June 9, 2016

RE: DRH16-00079 / 1101 W. Front Street

This letter is to inform you of the action taken by the Boise City Design Review Committee on the request for approval to construct a six-story, 145,000 square foot office building, four-story, 600 stall parking structure with 10,000 square feet of office/retail space on the ground floor, and a 5,000 square foot retail building in a C-5DD (Central Business with Downtown Design Review) zone.

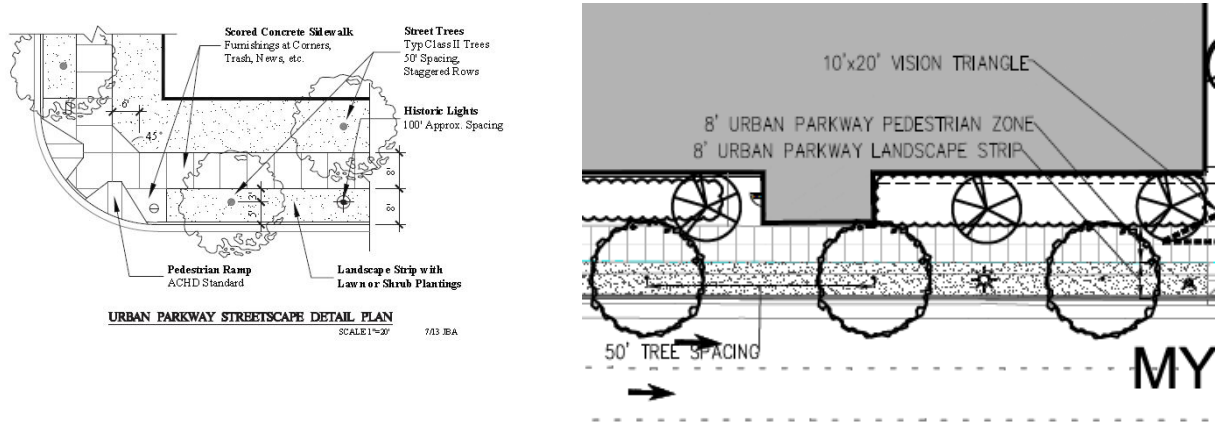
Though the design being installed along Front Street does not comply with the adopted guidelines, it does provide consistency from block to block. It also provides a better environment for the street trees to mature and have a strong root structure with the additional soil provided in the planter beds.

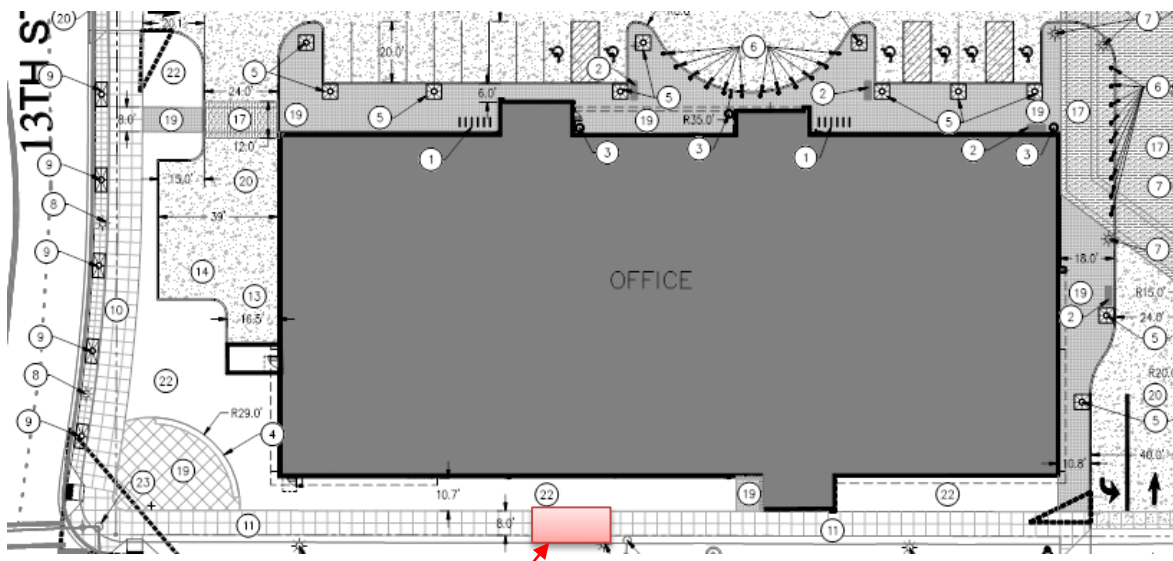
The mass of the parking structure is unique to the area. The length of the structure along Front Street is 302-feet and 185-feet along the 13th Street frontage. There is no significant modulation to the massing and minimal design interest provided at the pedestrian street level, with the exception of the 11th Street frontage. The Downtown Design Guidelines require structures with a length greater than 122-feet in the east/west direction contain significant stepping of the façade or articulation of the façade that runs to the pedestrian level. The Planning Team understands in order to provide for an efficient parking layout a rectangular structure is the most efficient and economical. However, if the Downtown Design Guidelines are to be waived for the requirement of a significant break in the façade to break up the massing, then additional detail needs to be provided throughout the structure for interest.

The provided garage elevations accurately depict the north and east elevations, showing aluminum store front window systems along 11th Street on the east elevation, and a tower massing at the northeast corner of the structure addressing the intersection. The west and south elevations, however, do not match the site plan or floor plans with regards to the location of the tower element proposed at the southwest corner of the structure. Revised elevations accurately depicting these elevations shall be submitted for review at a future public work session.

The proposal shows a change in how the shell of the structure is treated with perforated metal panels covering portions of the facade, with other areas left open into the parking. This detail does not extend down to the ground level, however. Any pedestrian, bicyclist or vehicle moving along the length of the structure on Front Street would see a flat continuous low masonry wall with visibility into a parking structure. There is no ground floor retail space proposed or required, but changes in material should carry to the ground floor at a minimum. On a previously approved project on this parcel, there was a similar discussion about continuing a proposed terra cotta tile system to the ground level on the parking structure. A concern with that proposal was the possibility of pedestrians attempting to climb or vandalize the terra cotta screen. With the change to a perforated metal panel, those concerns are no longer present and the material should be continued to the ground. This change should take place on the entirety of the building to provide a consistency in application of materials.

4. Detail the upper decks of the parking structure, modifying the proposed cable rail system to provide increased opacity and visual screening of vehicles.

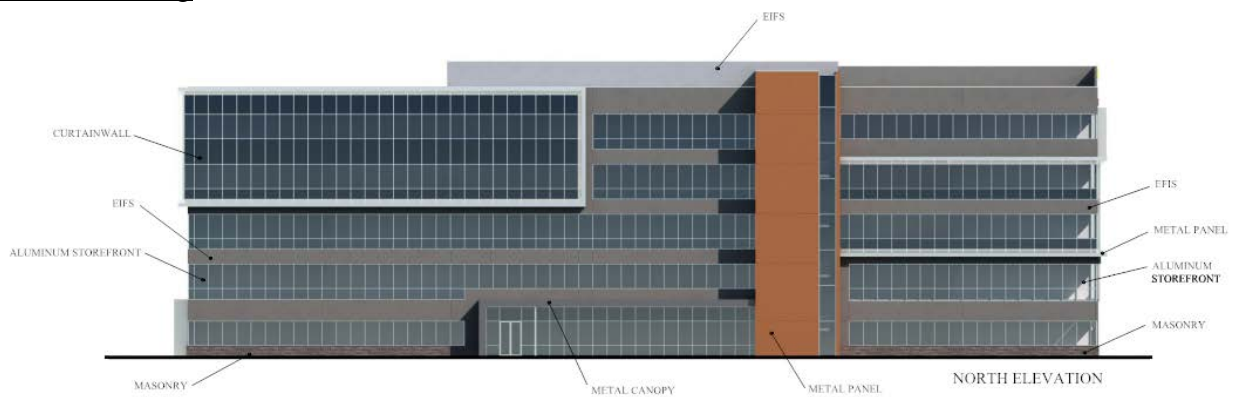
Large expanses of transparency are proposed on all of the buildings. Details on the proposed window openings shall be provided at 60-percent construction documents to show how the windows meet the face of the adjacent materials. The Downtown Design Guideline 4.3.2 states:

Buildings shall employ techniques to recess or project individual windows above the ground floor at least two (2) inches from the façade. For building outside the Downtown Core (area between 3rd, 13th, Washington, and Myrtle Streets) another option is to incorporate window trim at least 4 inches in width that features color that contrasts with the base building color. Glass curtain walls are exempt from this standard.

The proposed office building uses a curtain wall system which requires no depth of recess in combination with storefront windows which do require a two inch depth from the façade. Details should be provided to demonstrate how these standards are met. Additionally, details shall be provided on the storefront window systems on the retail building and parking structure to ensure compliance.

- b. At 60-percent construction documents the following shall be provided:
 1. Details showing a minimum of a 2-inch depth from the face of the glazing to the finish face of the surrounding material, with the exception of the curtain wall systems.

4.4.1 Quality building materials

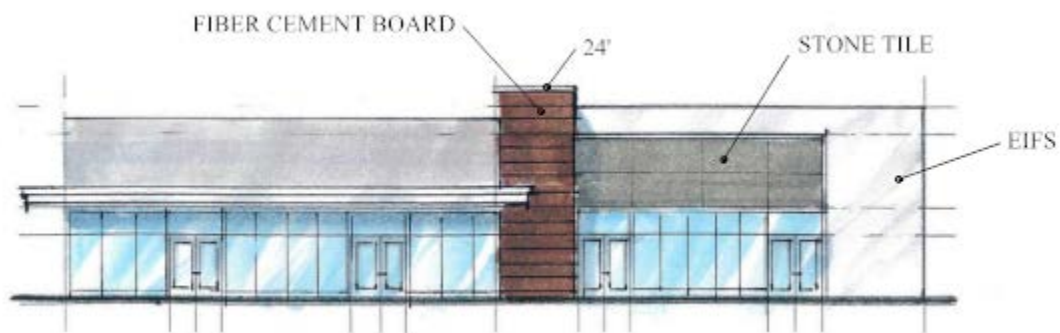
The office building uses a masonry base along with large areas of windows and metal to provide a base for the building. The upper levels of the building use mainly gray EIFS, aluminum storefront windows, and a curtain wall system. The Guidelines have three specific conditions for the use of stucco (EIFS) or other similar troweled finishes. They are as follows:

- a. Stucco is strongly discouraged in commercial projects and on the first floor of multi-family residential buildings.
- b. Stucco must be trimmed in wood, masonry, or other material and shall be limited to no more than 50 percent of the street façade; and
- c. Stucco shall not extend below two feet above the ground plane. Concrete, masonry, or other durable material must be used for wall surfaces within two feet of grade to provide a durable surface where damage is most likely.

Though stucco EIFS is strongly discouraged for commercial projects, the applicant has chosen to move forward with the use of the product on the upper levels of the structure. The applicant has previously received approval to use an EIFS product on the subject parcel and it has been found to be appropriate for the site context and surrounding area. The EIFS proposed has been trimmed with windows and metal, and does not extend below two feet above the ground.
